### **STATUTORY CONSULTATION ON THE SOUTH EAST STRATEGIC RESERVOIR OPTION (SESRO) IN ACCORDANCE WITH S42 OF THE PLANNING ACT 2008**

Thank you for your correspondence dated 28 October inviting Vale of White Horse District Council (VWHDC) to comment on the statutory consultation materials ahead of the full submission for a Development Consent Order (DCO).

Figure 3-1 Groundwater conceptual model – pre-development conditions

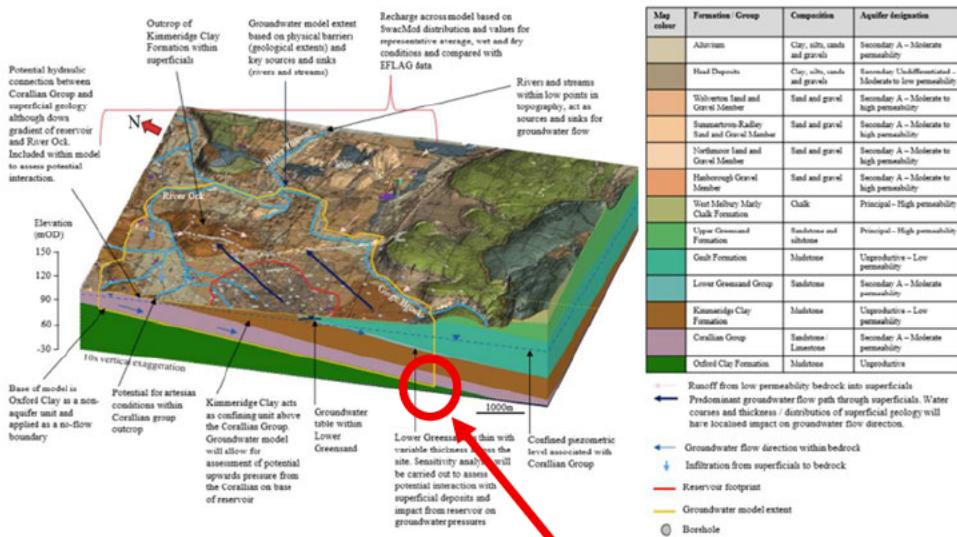
*Based on Figure 3.1 and Paragraph 4.4.2 ‘... constant head boundaries will be applied to the model edge along the Corallian Group and Lower Greensand aquifers as they are considered a constant source of water within the model’.* It appears that the geological boundary of the Corallian Limestone at depth (circled below) is proposed to be a constant head boundary.

As groundwater flow is indicated in Figure 3.1 as being downwards, towards this boundary, it would appear as if it will, therefore, act as a sink rather than a source and consequently may numerically remove water from within the groundwater model (and reduce modelled flood risk at the surface). If so, this may be difficult to quantify and be a potential source of numerical error. VWHDC expect this boundary (and others) to be independently checked using appropriate water budget calculations, to be presented as part of the model calibration exercise.
